# SERVICE BULLETIN

SB No. 51 Issue No. 1

**TITLE**
**INSPECTION OF RUDDER CABLE TO LINK PLATE SOCKET HEAD CAP SCREW**
**CLASSIFICATION**

All T67 GRP series aircraft Post Mod 95.

Fig 1

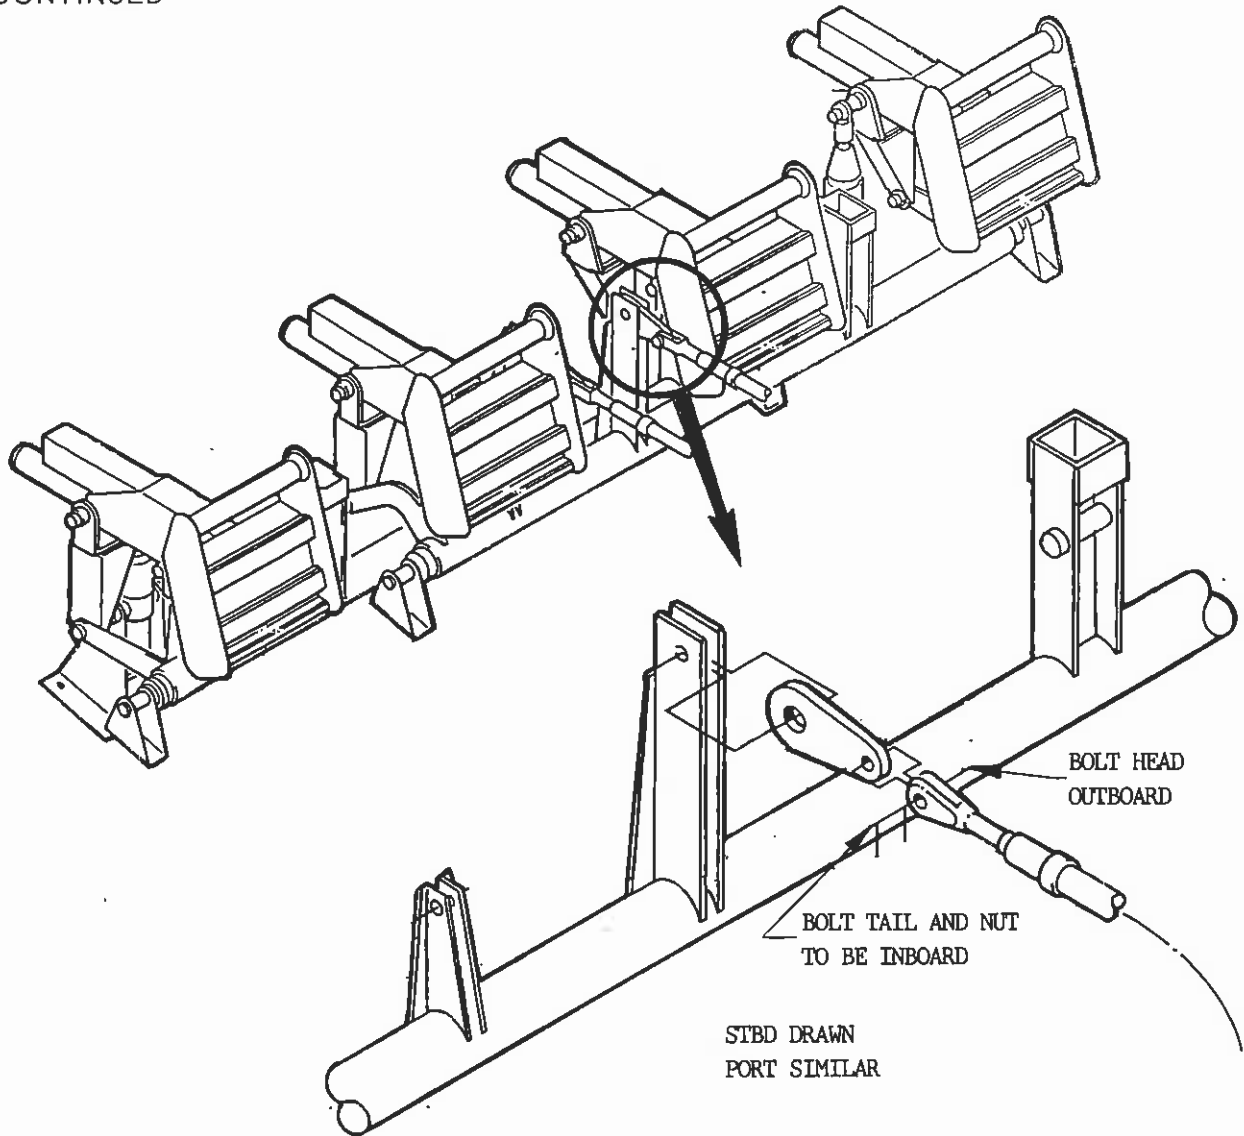
Following an incident whereby the rudder pedal fouled on the rudder cable link plate bolt tail, subsequent inspection found that the bolt was incorrectly assembled.

1. Refer to Fig. 1. Check the direction of the head of the bolt. It must be outboard, ie towards the No.3 pedal and a minimum clearance of 8mm from the pedal must be present after taking up any slack or backlash in the rudder pedal system.
2. If it is not in the correct orientation, remove and replace it with the bolt head adjacent to the rudder pedal.
3. Some aircraft have a socket head cap screw fitted pre Mod M471. SAL Mod M471 is available to fit a pan head bolt which increases the clearance to the rudder pedal, if required.
4. If the required clearance is not achieved through correct orientation and implementation of Mod M471, contact SAL Product Support Department for further information.
